ADDENDUM NO. 2

IFB 2018-04-517-PR
New Copper Gutter System and Related Work – Field 10 and 11
Laumeier County Park – Estate House Parks Project PB607
May 10, 2018

IFB 2018-04-514- PR
ADDENDUM #1 Item 1.4
1993 File Drawing for Reference.
Bidders to verify conditions prior to submittal
of Bid.

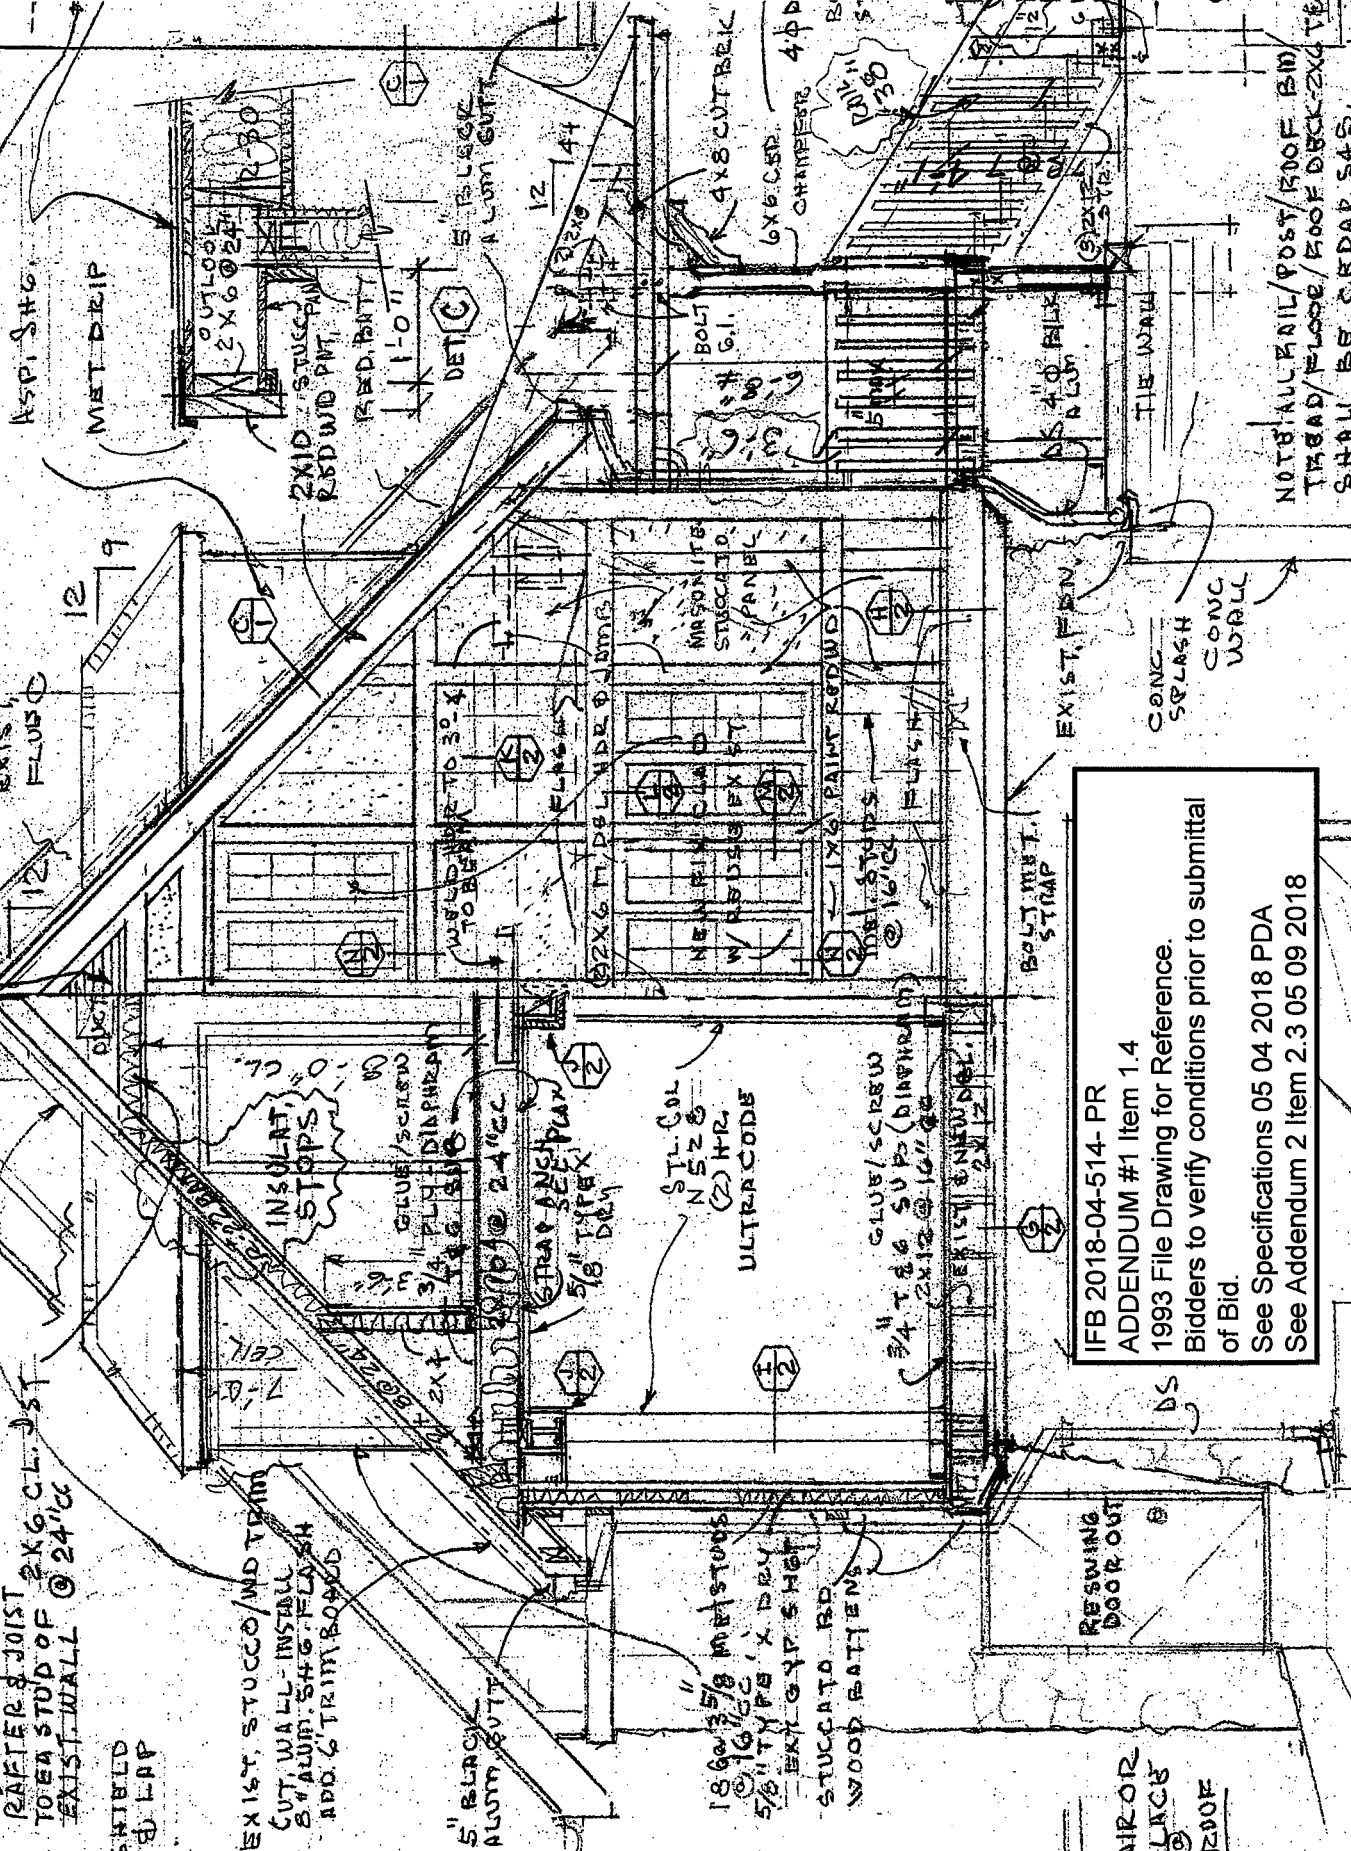
The 1993 File Drawing for Reference to the Add Alternate Bid Item #1 "Removal and Replacement of the existing Architectural Composition shingles with Slate Roofing, and, replacement of the aluminum guttering and downspouts with copper half round guttering for the eastern building addition to match the Estate House" to have been provided as part of Addendum No. 1 Item No. 1.4 (issued May 4, 2018) was omitted from Addendum No. 1 and is attached hereto, and made part of Addendum No. 2.
